# O1 DARM Loop Design Comparisons and Critiques

J. Kissel, for the ISC and Calibration Teams

# Actuator Comparison (Hierarchy Filters)

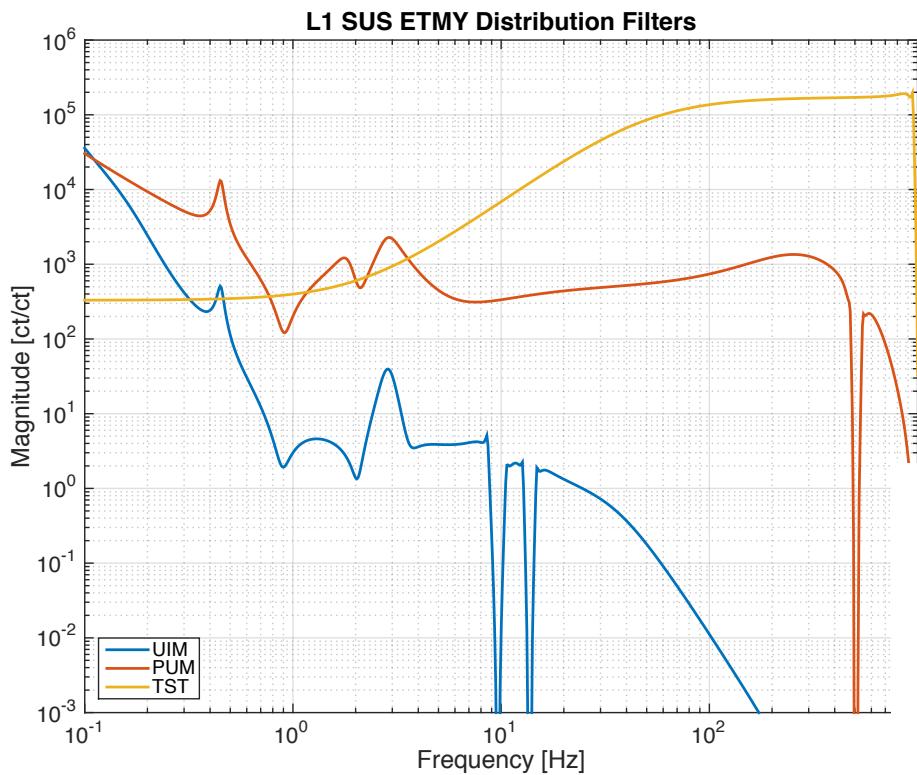
Note the difference in HF cut-off filter for all stages...

Both sites have a mish-mash of “offloaded” vs. “distributed” hierarchy filters due to staggered design

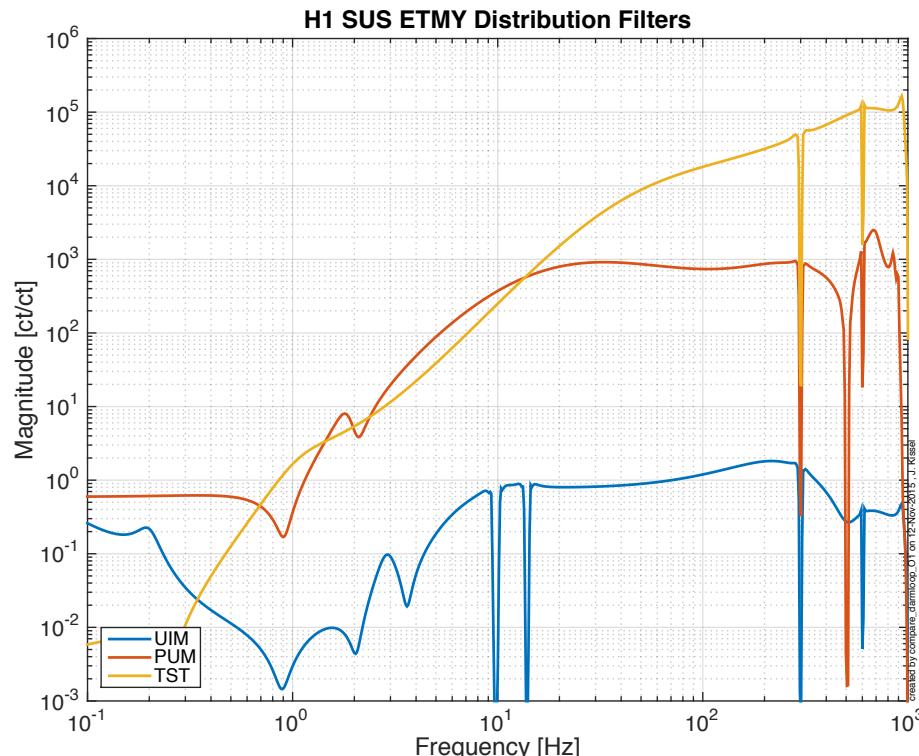
L1 does more loop shaping in the DARM bank (because of all the notching done at H1)

# The DARM Filter and Sensing Function

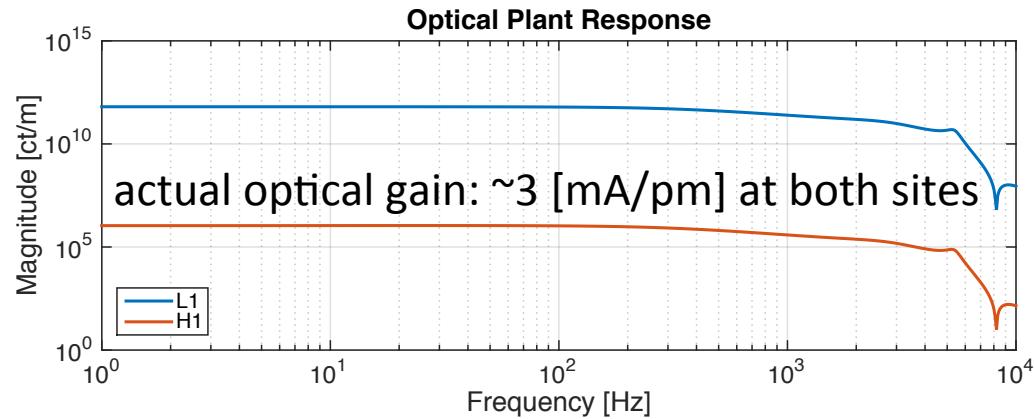
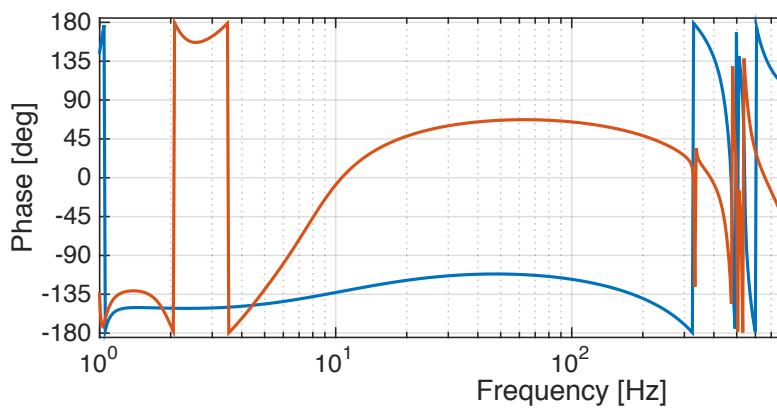
Digital gains (and a sign) are distributed differently on the sensing side, so DARM filter gain and sign compensate, otherwise pretty similar...

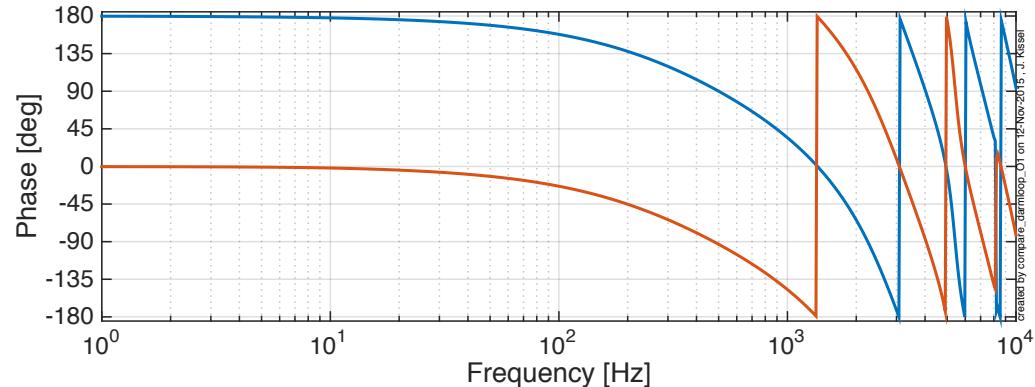
But because of the **different design choices**, with frequency response and gains all over the place, **tough to get a feel for the loop shaping from just one filter or plot**

# Conclusions

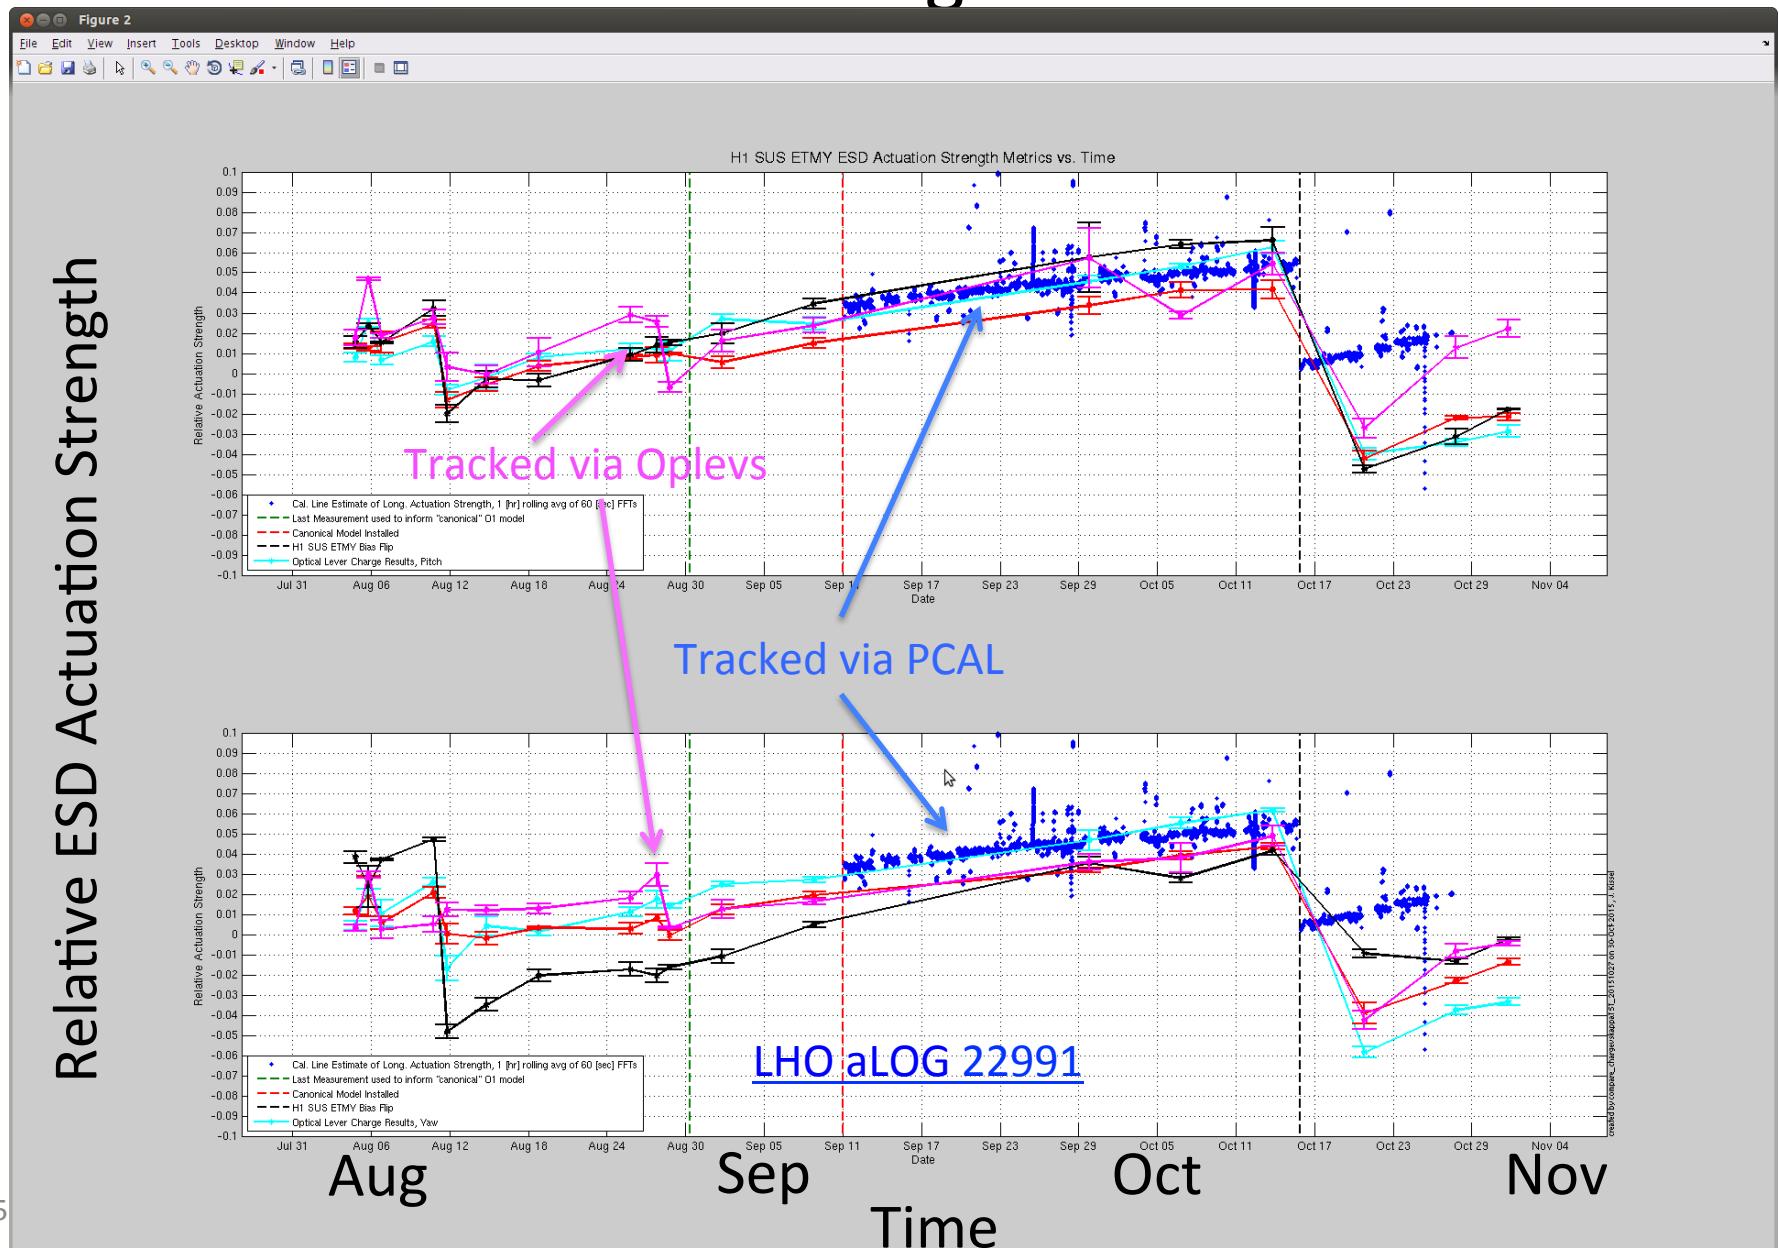
- H1 DARM Loop needs some tune-up and clean-up
  - More boosting at low-frequency
  - Better / simpler distribution filters
  - Less notching?
- Frequency response is splayed out everywhere at both sites, evident that “design” was staggered and piecemeal
  - Both sites should consider consolidating, for easier analysis of performance
